# Historic Preservation Design Review

October 27, 2011

HP-11-25, 405 W. Calhoun St. & 202 N. Purdy St. (City)

**Request:** Design Review for a new attached garage, colonnade, brick fencing/wall, new & expanded door openings on the rear of the principal structure, and expanded window openings to the rear of the principal structure, new in-ground swimming pool, and pool house at 405 W. Calhoun St.

*Above:* Proposed front, exterior side, and rear elevations of the attached garage; as well as the attachment point and new entry door to be on the main dwelling.

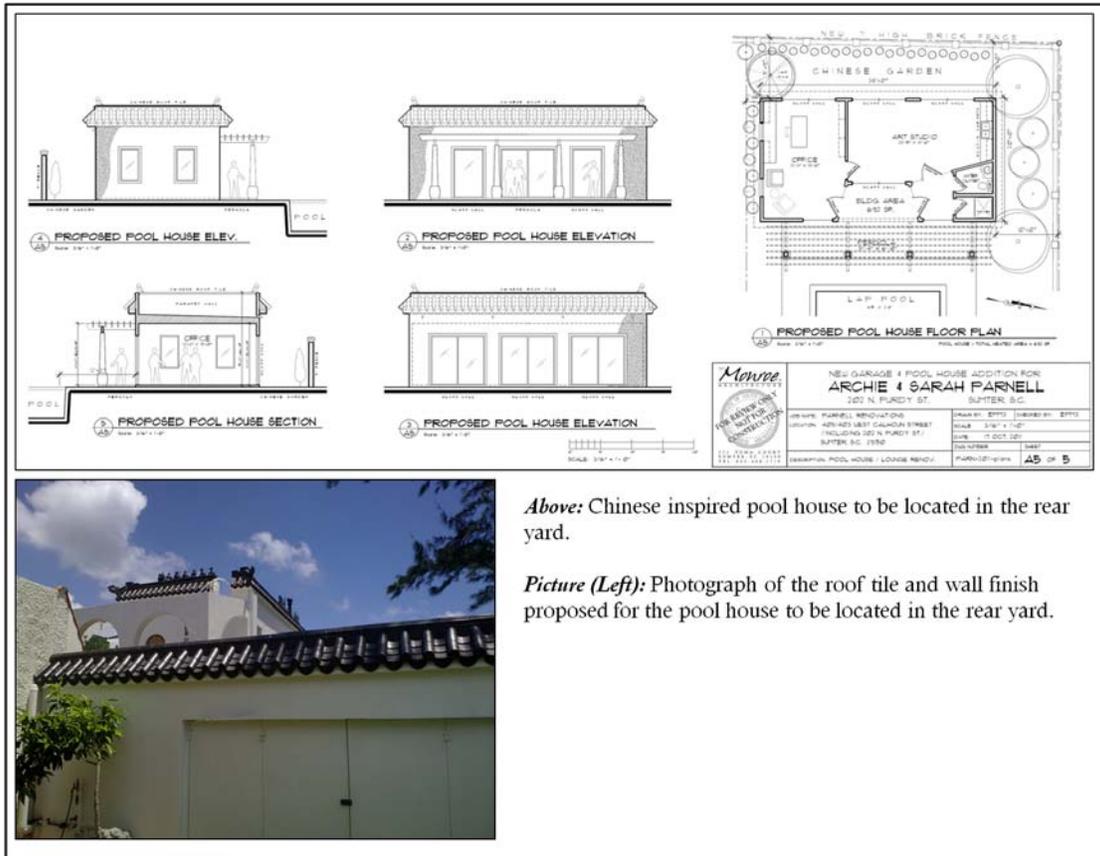
Overall the request as submitted meets the above outlined guidelines. All proposed modifications to the original structure are on the rear or not readily visible facades. Although the garage addition is on a readily visible secondary façade, the use of landscaping helps to mask the massing of the structure at the street level, and the exterior side of the structure has been designed to give the appearance of a primary entrance to the structure.

Staff recommends approval of this request. The proposed project generally meets the requirements set forth in the design review guidelines and the colors and materials proposed are compatible with the existing dwelling.
